**Addendum No. 1**

RE: Contract # C204773

INTERSECTIONS OF NC-7 AND SR-2083 AT US-74, BRIDGE #350091 OVER  
CATAWBA RIVER ON US-29/74.

The following revision has been made to the Structures plans.

SHEET 8 OF 10

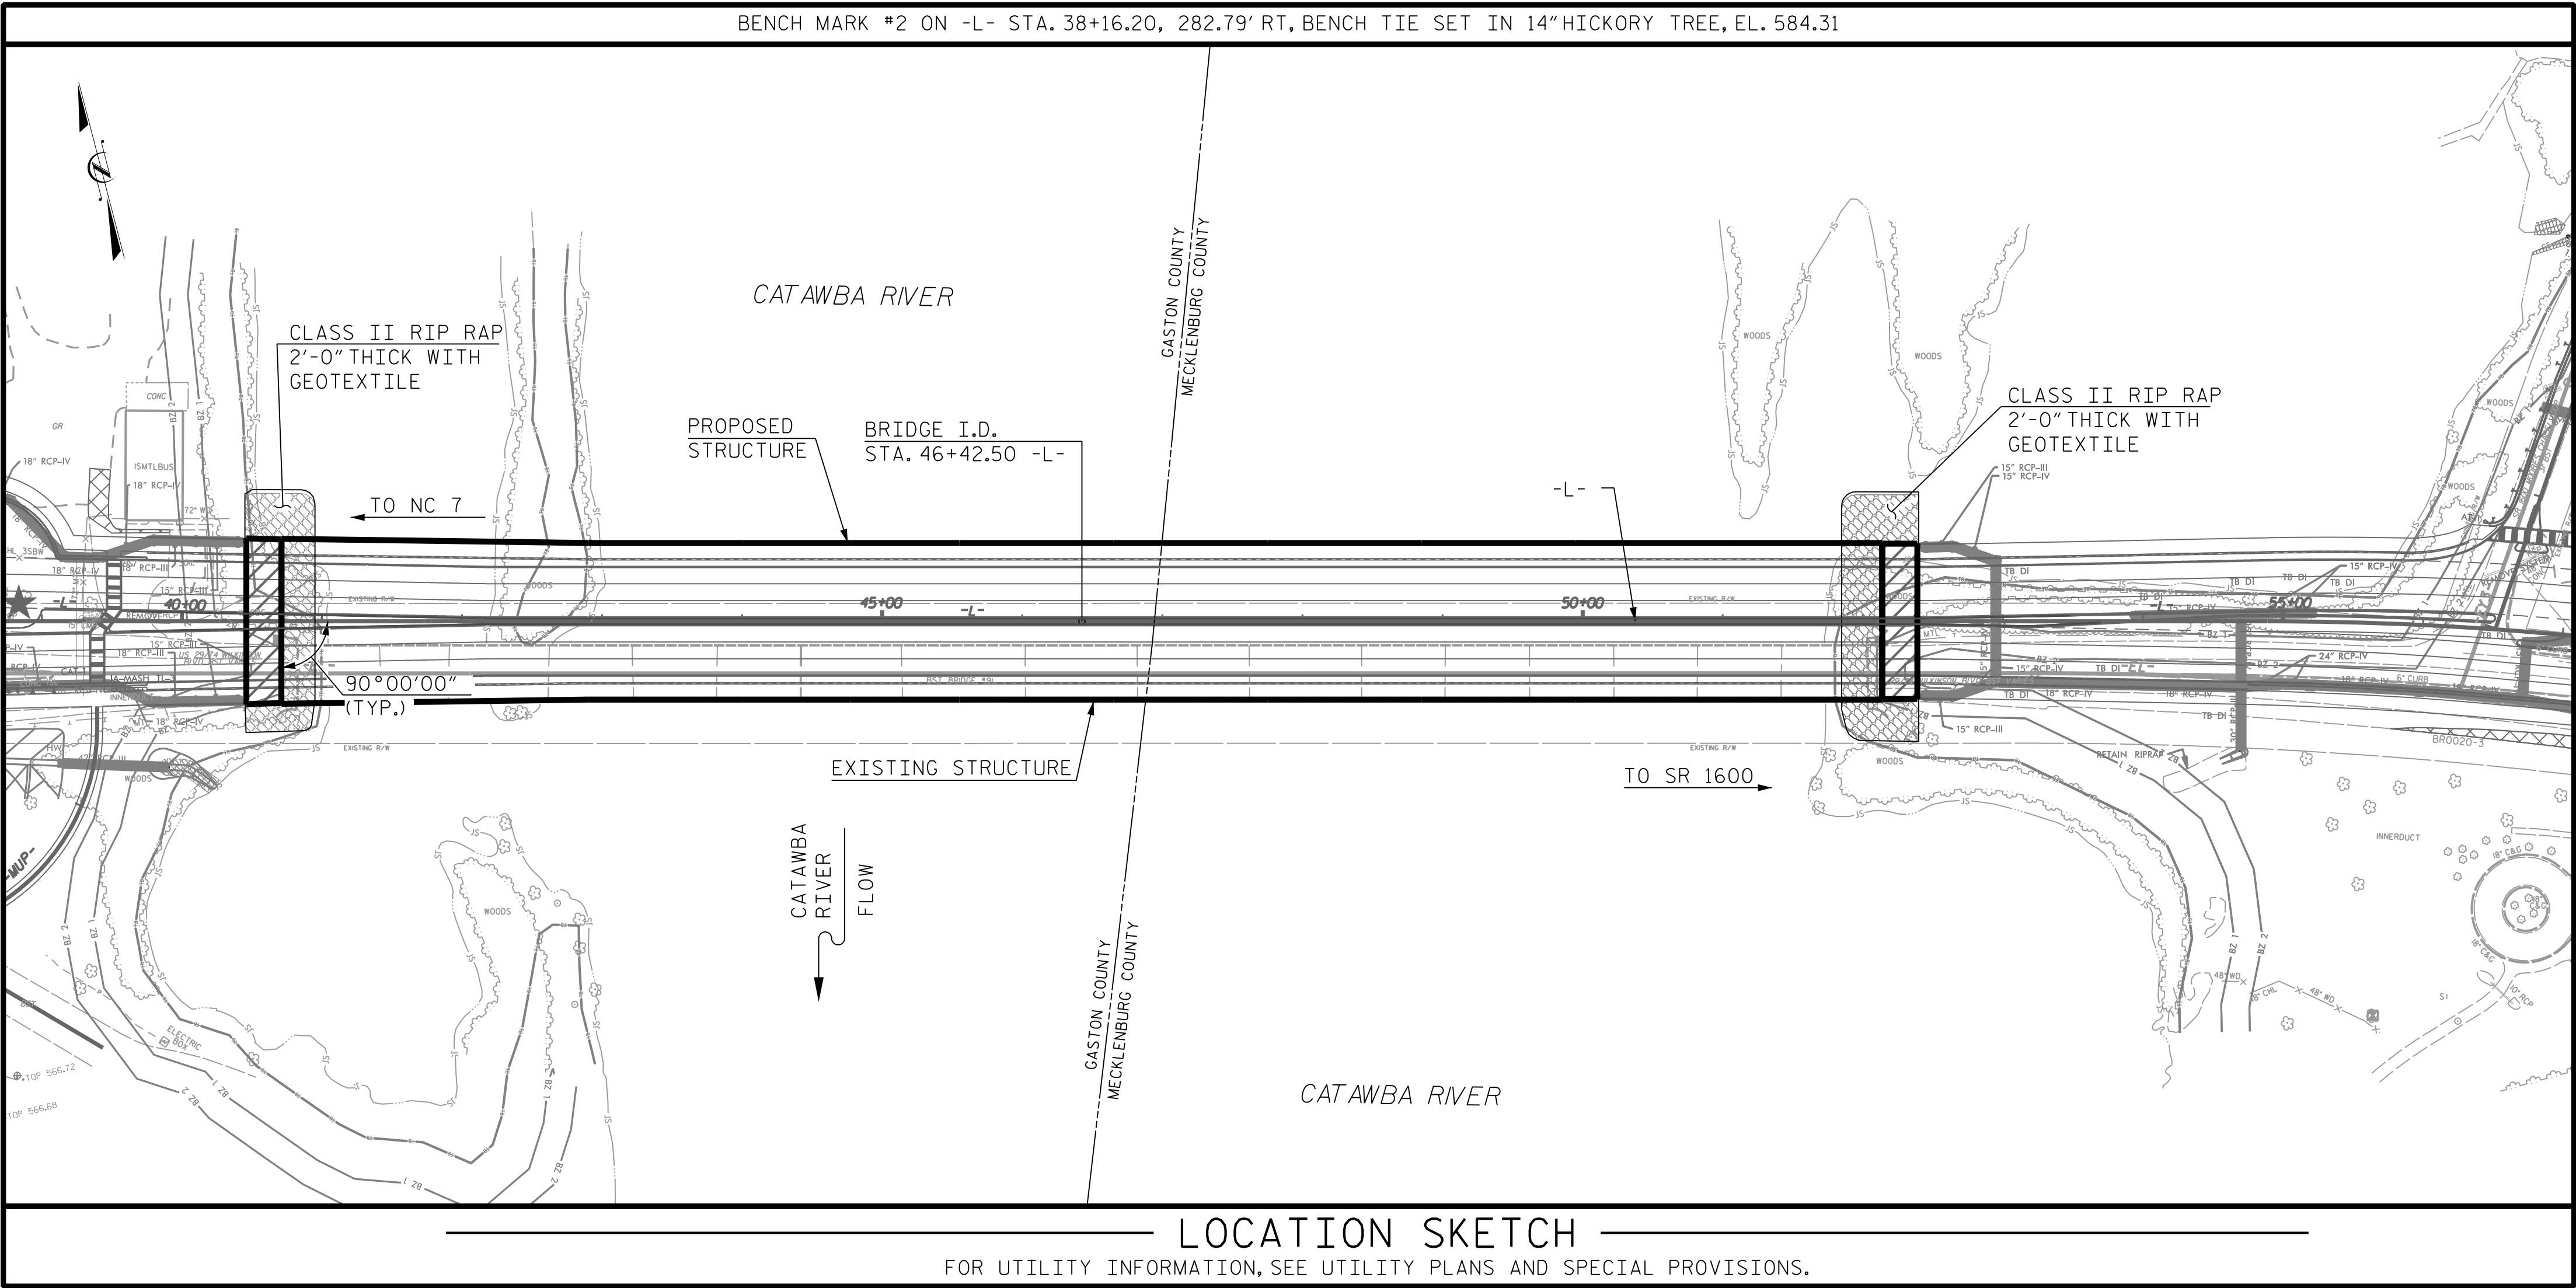
| Sheet No. | Revision                         |
|-----------|----------------------------------|
| S-8       | General notes have been revised. |
